**CERTIFICATE OF APPROPRIATENESS**

**Property:** 1115 Arlington Street, Lot 1, Block 198, Houston Heights Subdivision. The property includes a historic 2,532 square foot (including an addition constructed in 2000) residence situated on a 6,600 square foot (50' x 132') interior lot.

**Proposal:** Alteration – Addition: Remove the existing rear addition built in 2000 and construct a new 2,236 square foot addition to the rear of, to the side of, and on top of the original house.

**Recommendation:** Denial - does not satisfy criteria: 1, 4, 8, and 9.

**SOUTH SIDE ELEVATION**

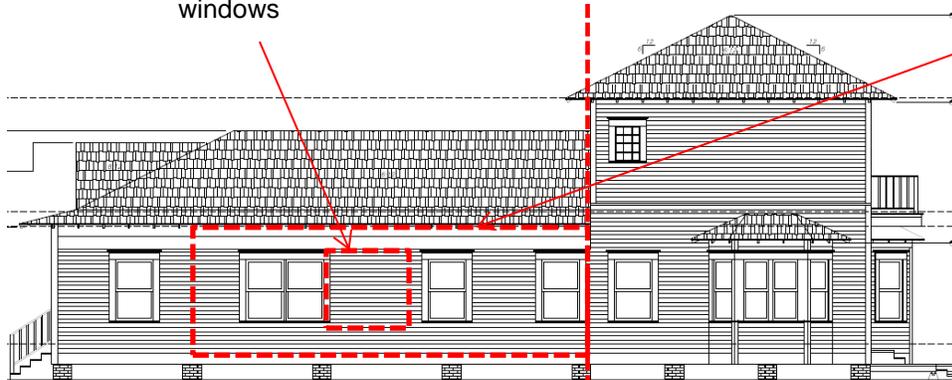
**Side Elevation:** The addition will encroach over the rear 10' of the existing original residence. Replace a non-  
**(South)** original glass block bay window with a pair of new wood windows.

**NORTH SIDE ELEVATION**

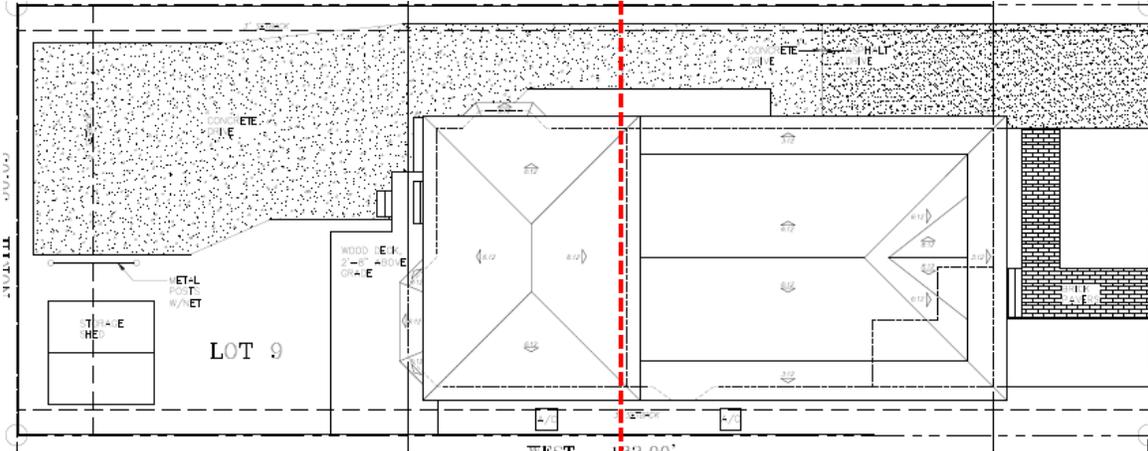
Hole cut to incorporate new windows

Existing wall to be removed

Proposed 9' by 1' bump out

**Side Elevation:** The addition will begin the addition 12' 3" from the front wall of the existing residence by  
**(North)** constructing a 1' wide by 9' deep bump out. The remaining 31' of the historic exterior wall from this point back will be removed and replaced with new material. The second story of the addition will encroach over 10' of the original residence.

PROPOSED FLOOR PLAN

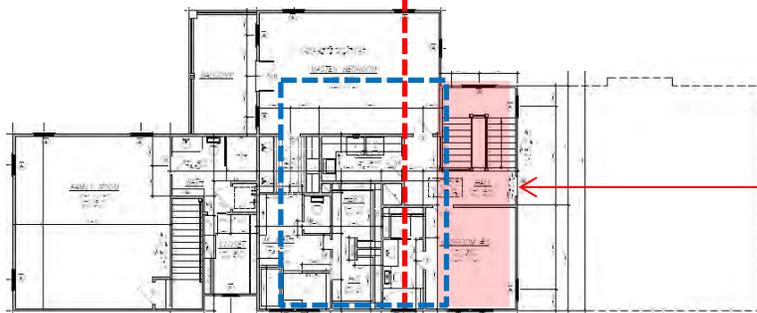
Red shaded area indicates the proposed second story encroachment over the existing original house

**DEMOLITION PLAN  
FIRST FLOOR**

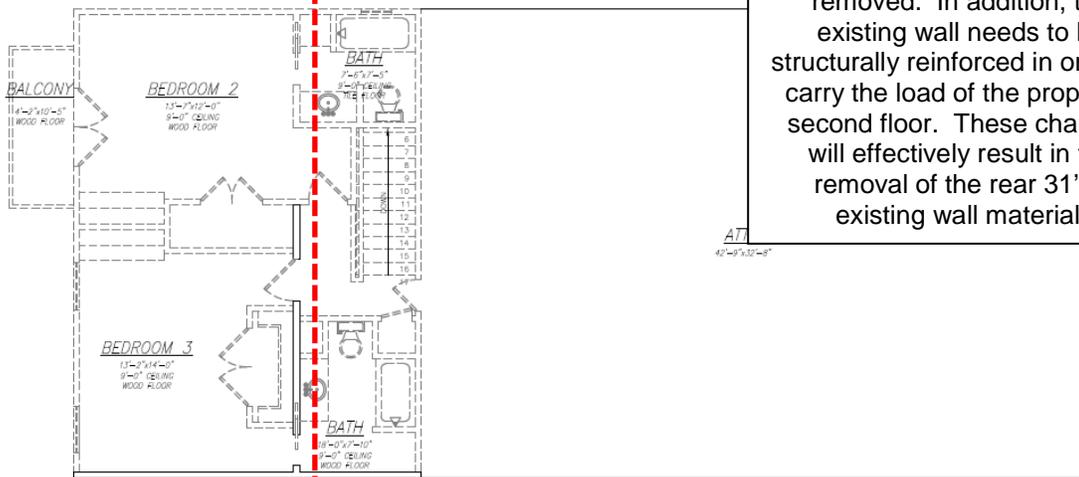
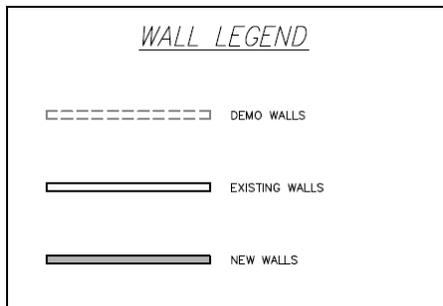
Highlighted hatched area indicates the existing window and wall material proposed to be removed. In addition, the existing wall needs to be structurally reinforced in order to carry the load of the proposed second floor. These changes will effectively result in the removal of the rear 31' of existing wall material.
